*Re: Applications of 45 Hurlingham, LLC for Site Plan, Special Permit, Wetlands Permit  
and Tree Removal Permit Approvals to Construct a New Residence, Caretaker's  
Quarters, Driveway, Tennis Court, Dock and Related Utilities and Improvements  
Property: 45 Hurlingham Drive, Town of North Castle  
Tax Identification No.: Section 102.04, Block 1, Lot 26*

This submission is made to apprise the Board of some changes to the site plan requested by our client, as well as to clarify or provide additional information to address questions and comments raised in the Review Memoranda of the Town Planner dated February 12, 2021 (the "Planning Memorandum") and Consulting Town Engineers, dated February 17, 2021 (the "Engineering Memorandum").

# SITE PLAN REVIEW SET PROPOSED RESIDENCE

SHEET	TITLE	REVISION	DATE
-	TOPOGRAPHIC SURVEY	-	06-01-21
-	ZONING LOCATION SURVEY	-	06-01-21
1 OF 4	DEVELOPMENT PLAN	2	06-01-21
2 OF 4	SEDIMENTATION & EROSION CONTROLS	1	06-01-21
3 OF 4	NOTES & DETAILS	1	06-01-21
4 OF 4	SEPTIC DESIGN & DETAILS	1	06-01-21

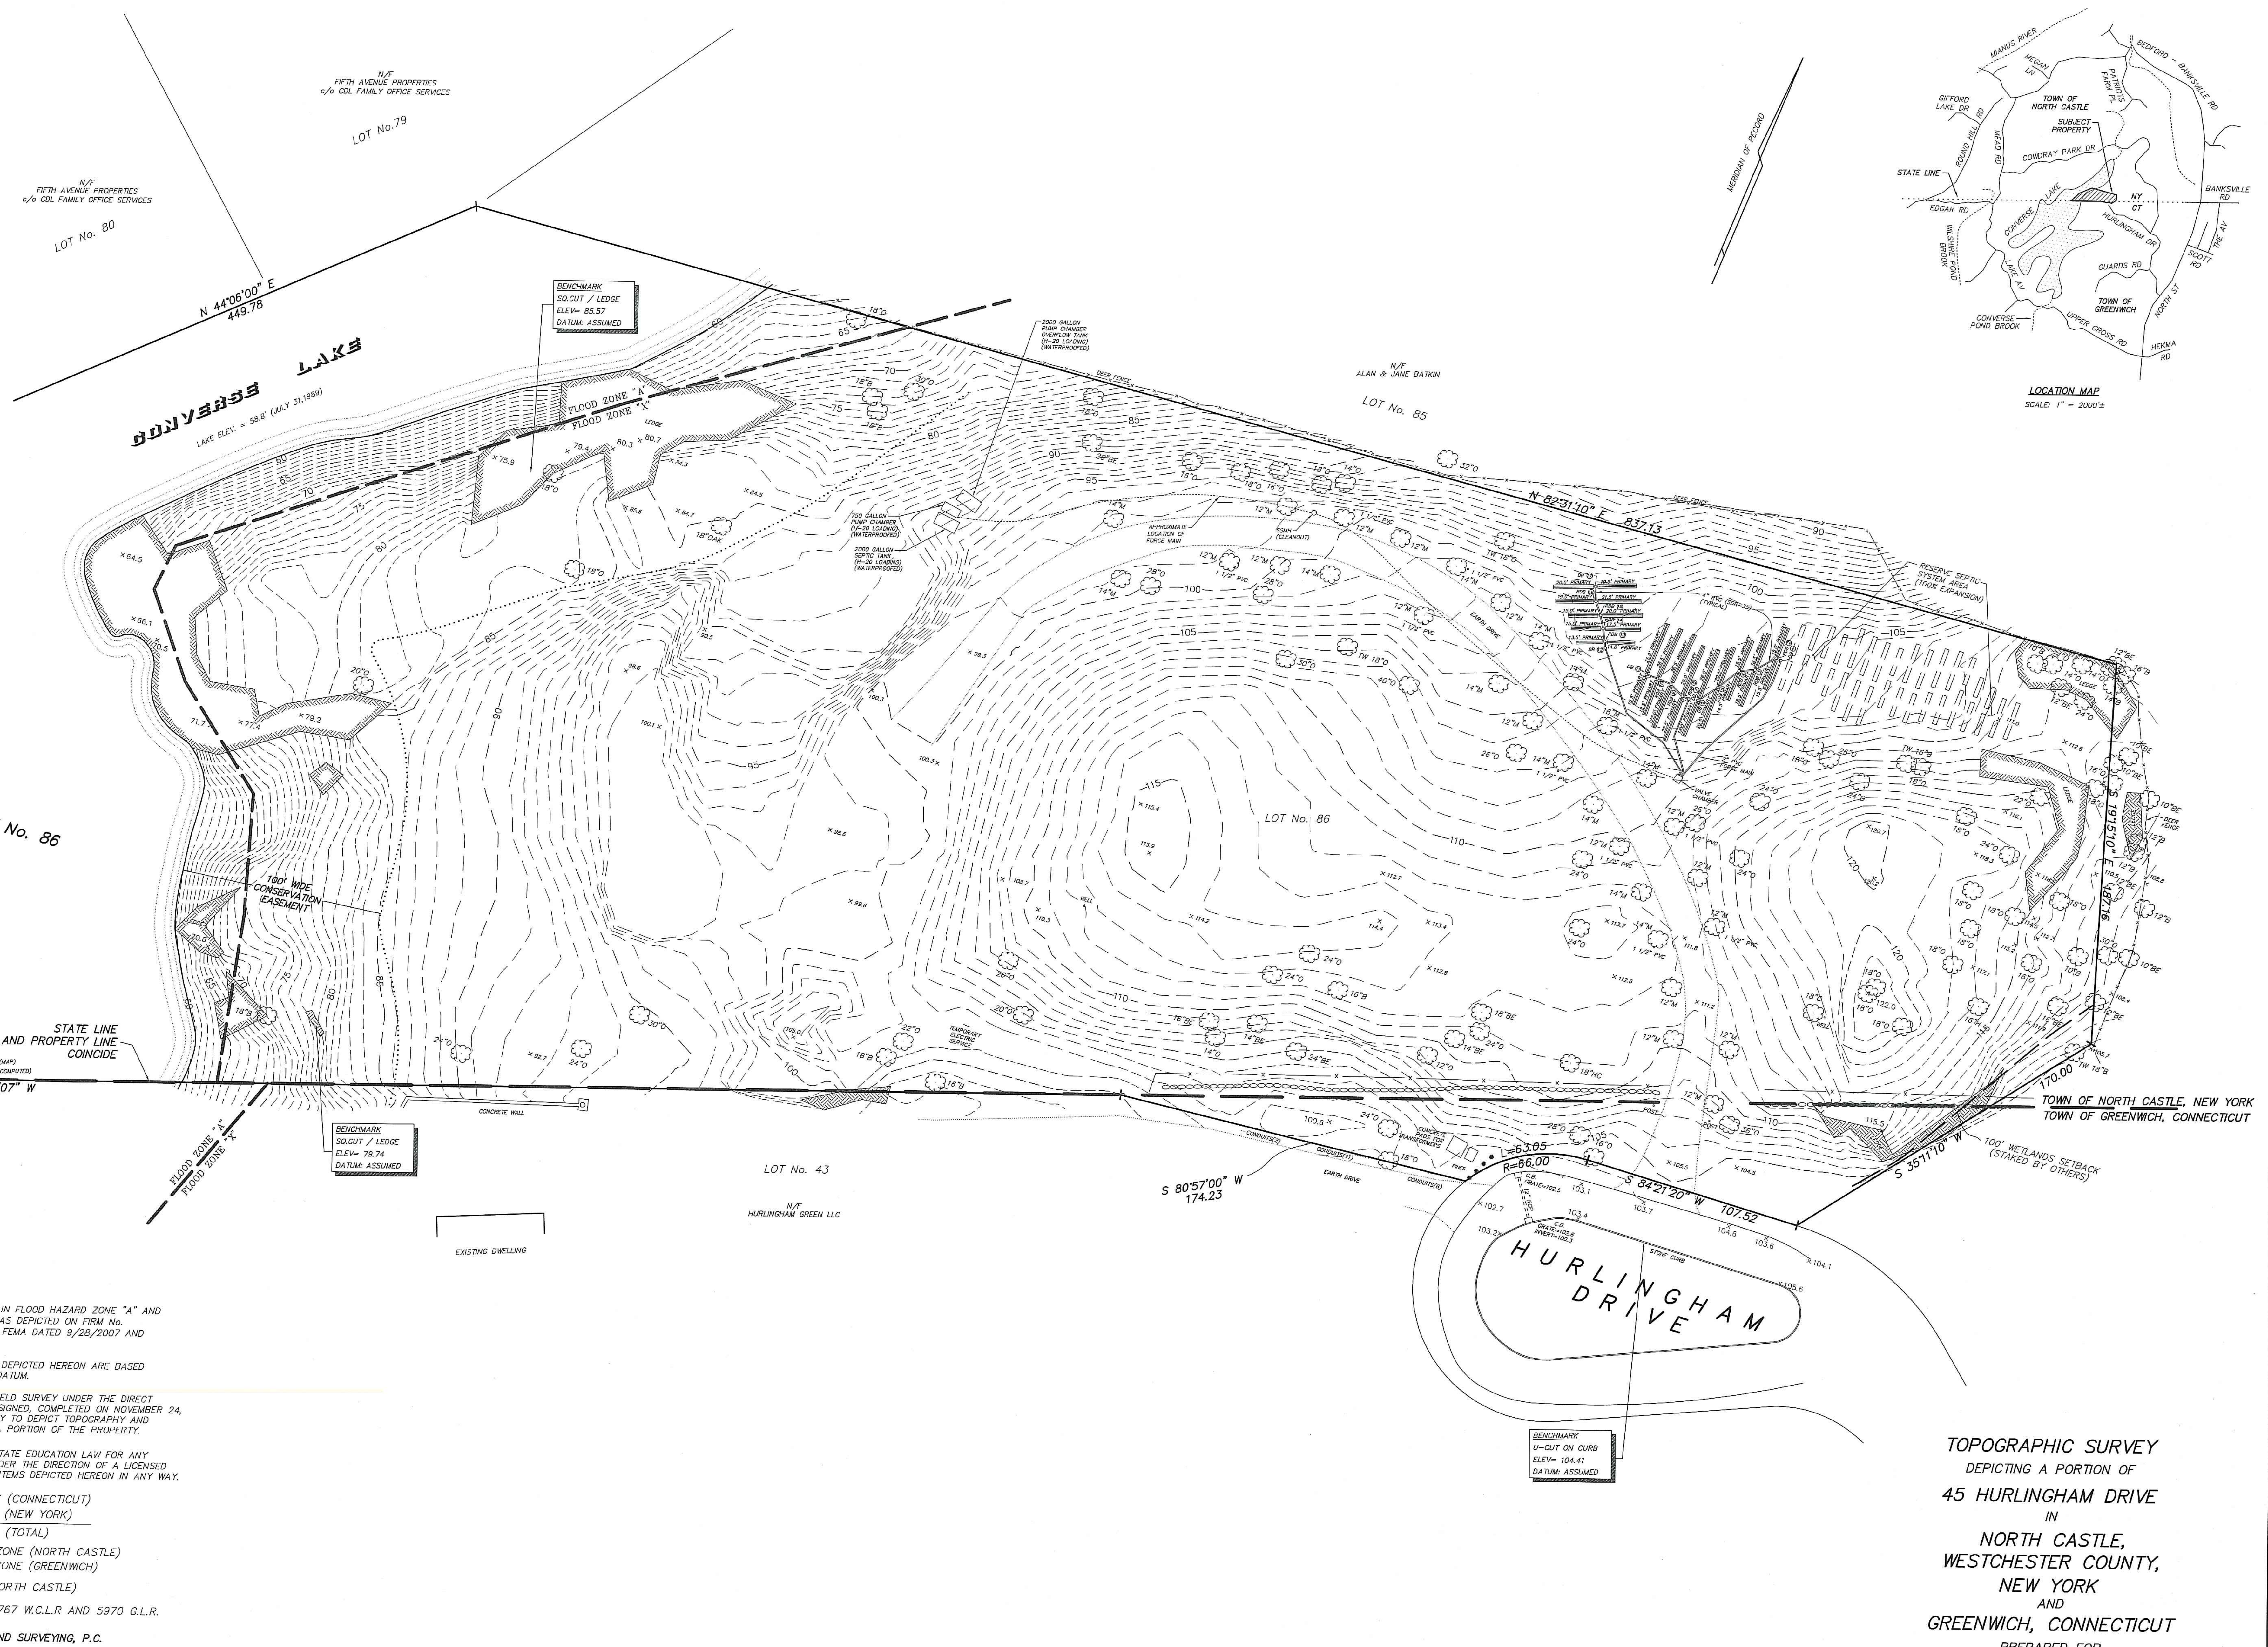
2. No response required.
3. The Development Plan (item 1(a)(iii)) has been revised to depict the proposed amount of Town-regulated wetland disturbance and Town-regulated wetland buffer disturbance. The Landscape Site Plan (item 3) includes mitigation at a ratio of at least 2:1.

7. The Development Plan (item 1(a)(iii)) includes dimensions for the setback of the gate from Hurlingham Drive, the driveway width, proposed passing areas and the driveway courtyard.

8. The minimum required yard setbacks have been added to the Zoning Location Survey and Development Plans (items 1(a)(ii) and (iii), respectively).

13. No outdoor lighting is proposed for the tennis court (*see* the Development Plan, item 1(a)(iii)). Fencing details will be provided in the future.
14. Cut and fill calculations and related information can be found on the Development Plan (item 1(a)(iii)) and Earthwork Calculations Plan (item 1(a)(c)), which we believe represent a well-balanced site.

17. The plans have been revised to reduce the maximum height of the highest retaining wall (which is now 11 feet). A note has been added to the Development Plan (item 1(a)(iii)) to state that (a) all retaining walls equal to or greater than four feet in height will be designed by a NYS licensed professional engineer and satisfy all safety requirements including sliding, bearing pressure and overturning and (b) the design professional must certify that the construction of the walls conforms to the approved plans as a prerequisite to the Applicant obtaining a certificate of occupancy. (*See* General Note #11 on the Development Plan, item 1(a)(iii).)

20. Preliminary Comments on the SWPPP:
  - a. The layout of the Infiltration Chambers has been revised to conform to the NYS Stormwater Management Design Manual, in particular with regards to soil conditions. (*See* the Development Plan, item 1(a)(iii).)

- b. The inlet connections have been revised to be located at the top of the units. (*See* the Development Plan, item 1(a)(iii).)
  - c. The callouts for stormwater pipes have been revised as needed. (*See* the Development Plan, item 1(a)(iii).)

- d. The level spreader for Infiltration Chamber #2 is a continuation of the gravel bed surrounding the chambers. No pipe connection is needed. (*See* the Development Plan,

- item 1(a)(iii).)
- e. All grate and rim elevations for catch basins and junction boxes have been revised as needed. (*See* the Development Plan (item 1(a)(iii).)

- f. *See* the response to 20(c).
  - g. The locations and elevations of the tennis court and the chamber system that serves it have been revised. The chamber system is well below the tennis court and will not cause a tailwater effect on the tennis court drainage. (*See* the Development Plan, item 1(a)(iii).)

- h. The inspection port(s) for each infiltration chamber have been added to the Development Plan, (item 1(a)(iii)).
21. The driveway to the Caretaker's Quarters has moved to the south side of the building and is curbed. Runoff from this driveway will be collected and routed to Chamber #1. There will be no runoff from the driveway over the septic fields. (*See* the Development Plan, item 1(a)(iii).)

PROJECT: **PROPOSED RESIDENCE**  
 PREPARED FOR: **45 HURLINGHAM, LLC**  
 LOCATION: **45 HURLINGHAM DRIVE  
 NORTH CASTLE, NEW YORK**  
 SHEET: **2 OF 4**  
 TITLE: **SEDIMENTATION AND  
 EROSION CONTROLS**

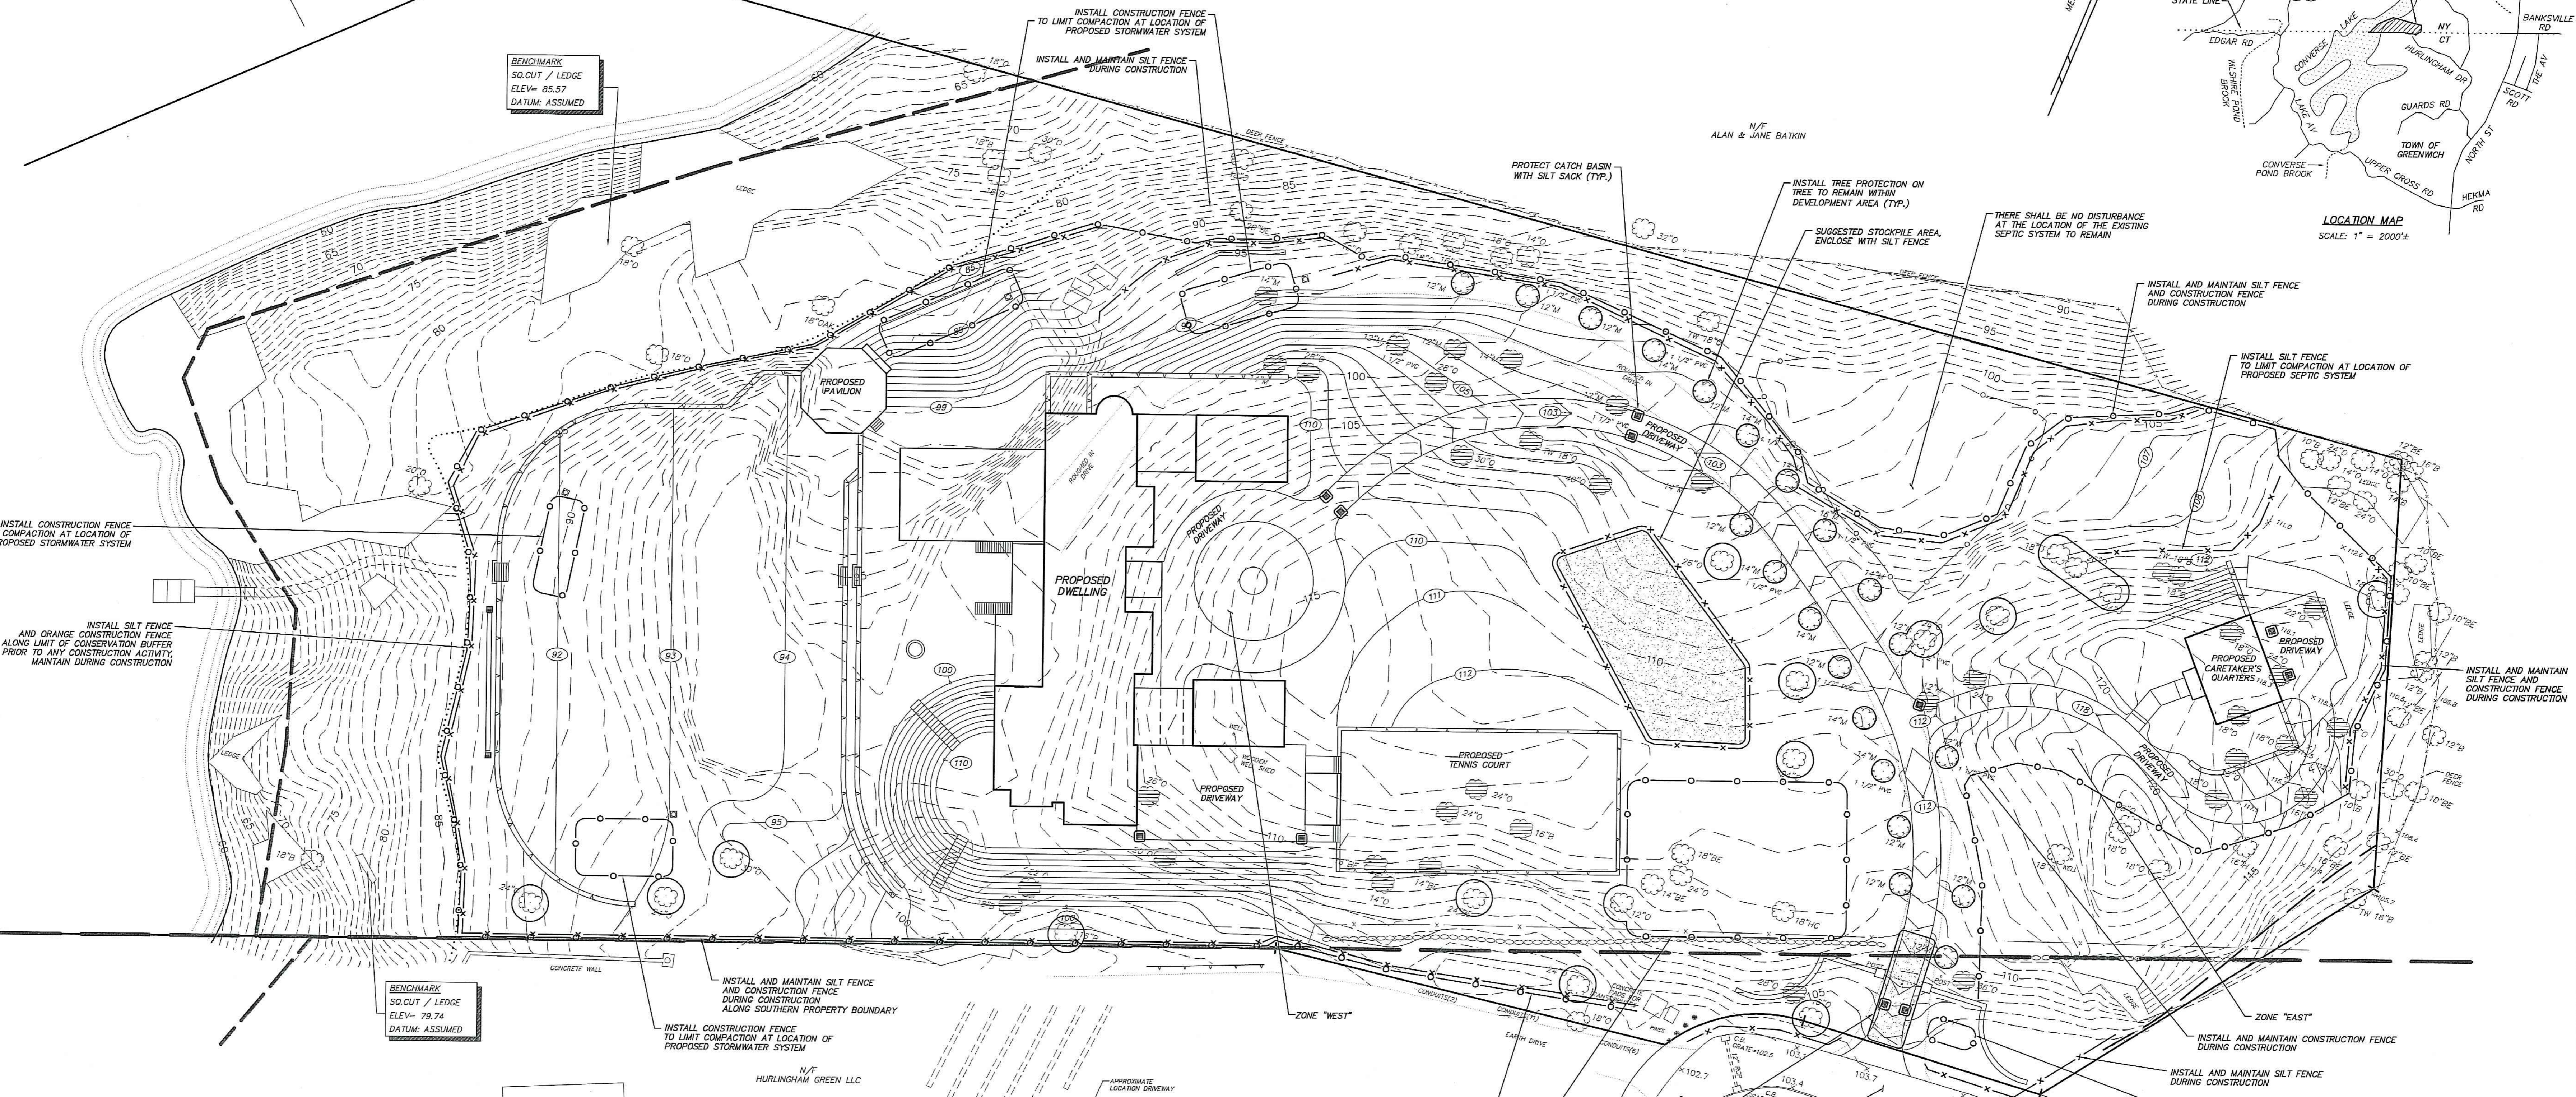
22. The Erosion and Sediment Control Plan (item 1(a)(iv)) has been revised to show the acreage in each disturbance area, none of which exceeds five acres. Total disturbance is less than five acres.

23. The Erosion and Sediment Control Plan (item 1(a)(iv)) has been revised to state that the limits of the Conservation Easement will be staked in the field with orange construction fencing prior to any disturbance occurring.

24. The Erosion and Sediment Control Plan (item 1(a)(iv)) has been revised to indicate that silt fence will be installed downgradient of all disturbed areas and parallel to the contours.

**CONCRETE RETAINING WALL DETAIL**

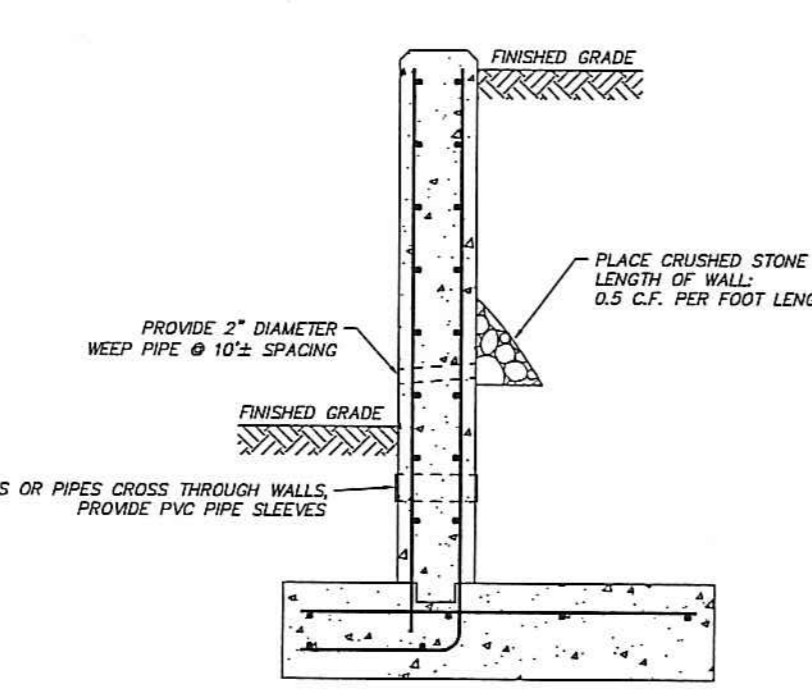
18. Revisions to the retaining wall detail are included on the Notes & Details Plan (item 1(a)(v)).
19. The retaining wall detail has been revised to show a sleeve for utility crossings. (*See* Notes & Details Plan 1(a)(v).)
